**Seely Recycling
Containment and Facility**

**Avian Deterrence System
Variance Request
Approval**

**3 Bear Field Services
June 2, 2020**

From: [LucasKamat, Susan, EMNRD](#)
To: [Liz Klein](#)
Subject: Approval with Conditions, Seely Recycling Containment and Facility (1RF-10), Avian Deterrence System Variance Request, Section 30. T18S, R34E (Lea County, NM)
Date: Wednesday, June 3, 2020 10:33:00 AM

**3Bear Field Service - Variance Request
OCD Permit: 1RF-10-0
C-147 Sealy Containment Pond and Recycling Facility**

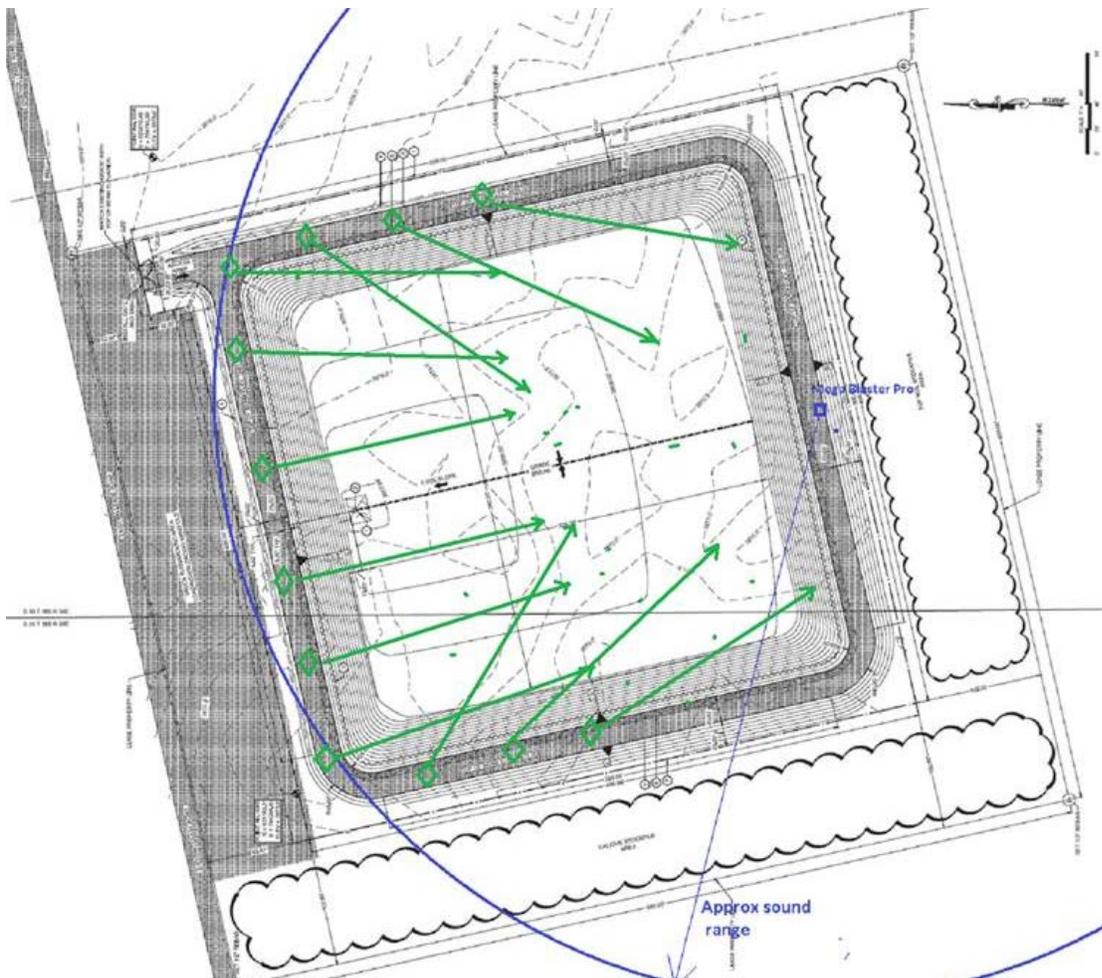
3 Bear Field Services, LLC requests a variance to the existing OCD Permit Number 10RF-10-0. The variance is to install a Bird-X deterrent system. The netting that was installed as part of the permit application/C-147 was completely torn off during a high wind event. We are requesting a variance to install a Bird-X bird deterrent system instead of replacing the netting. We are requesting this variance due to the high winds in the area and believe the deterrent system will be a more reliable bird deterrent system. The system is designed by Bird-X, Inc. The site map below shows the proposed installation details. Also attached is the deterrent system information and setup guidelines.

- The variance to 19.15.34.13 (E) NMAC for the installation of an audible avian deterrence system, a Bird-X Mega-Blaster, is approved.

The Form C-147 form and supporting documents submitted for the variance request for the Seely Recycling Containment and Facility is approved with the following conditions of approval:
